# 87C196JT Specification Update

Automotive

*December 1998*

Order Number: **273220-001**

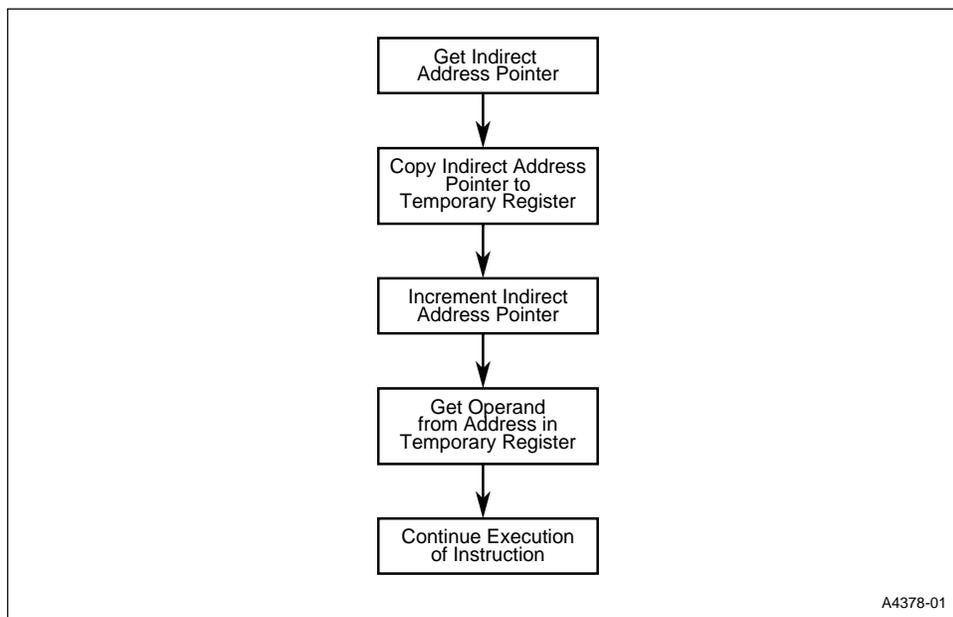
**Problem:** The EPA can lock up if overruns are handled incorrectly. Overruns occur when an EPA input transitions at a rate that cannot be handled by the EPA interrupt service routine. If no overrun handling strategy is in place, and if the following three conditions exist, a situation may occur where both the capture buffer and the EPA<sub>x</sub>\_TIME register contain data, and no EPA interrupt pending bit is set:

**Workaround:** Any one of the following methods can be used to prevent or recover from an EPA overrun situation.

- Clear EPAX\_CON.0  
When the overwrite bit (EPAX\_CON.0) is zero and both the EPAX\_TIME register than the buffer are full, the EPA does not consider a captured edge until the EPAX\_TIME register is read and the data in the capture buffer is transferred to EPAX\_TIME. This prevents overruns by ignoring new input capture events when both the capture buffer and EPAX\_TIME contain valid capture times. The OVRx pending bit in EPA\_PEND is set to indicate that an overrun occurred.

- Enable the OVRx interrupt and read the EPAX\_TIME register within the ISR  
If an overrun occurs, the overrun (OVRx) interrupt will be generated. The OVRx interrupt will then be acknowledged and its interrupt service routine will read the EPAX\_TIME register. After the CPU reads the EPAX\_TIME register, the buffered data moves from the buffer to the EPAX\_TIME register. This sets the EPA interrupt pending bit.

- Check for pending EPAX interrupts before exiting an EPAX ISR  
Another method for avoiding this situation is to check for pending EPA interrupts before exiting the EPA interrupt service routine. This is an easy way to detect overruns and additional interrupts. It can also save loop time by eliminating the latency necessary to service the pending interrupt. However, this method cannot be used with the peripheral transaction server (PTS).

**Figure 1. 16-bit System with EPROM**

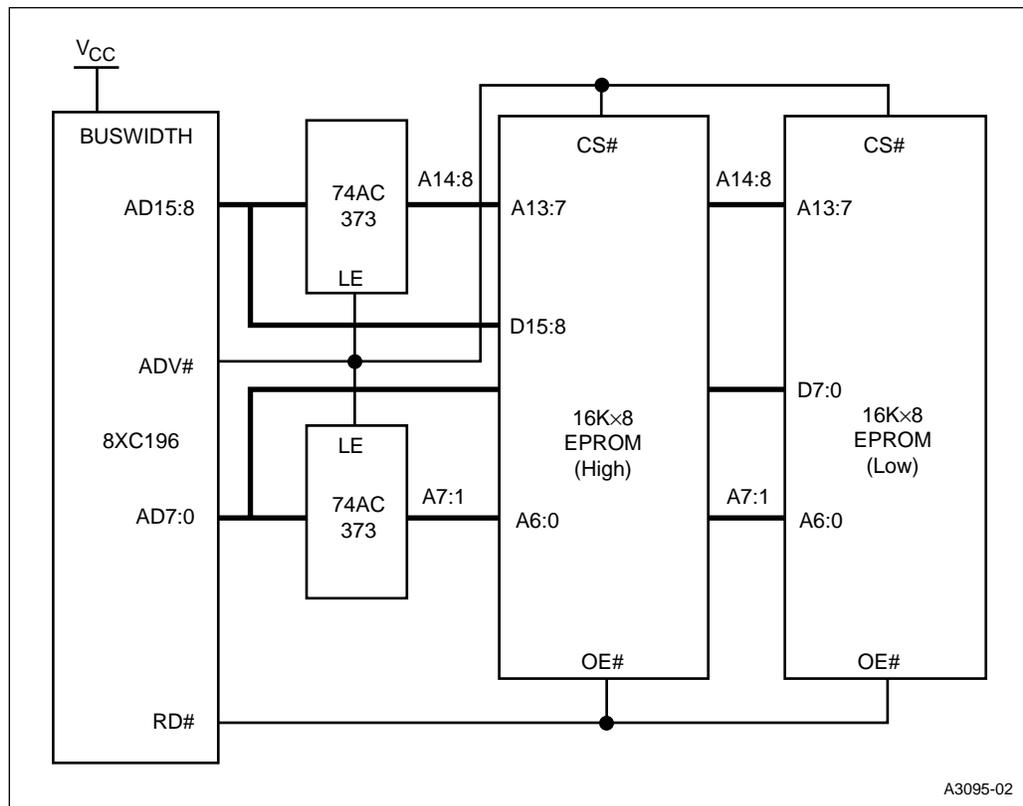
**1. High address inputs to the low EPROM should be A14:8 in Figure 15-18**

**Issue:** The next revision of the user’s manual will include the following corrected graphic.
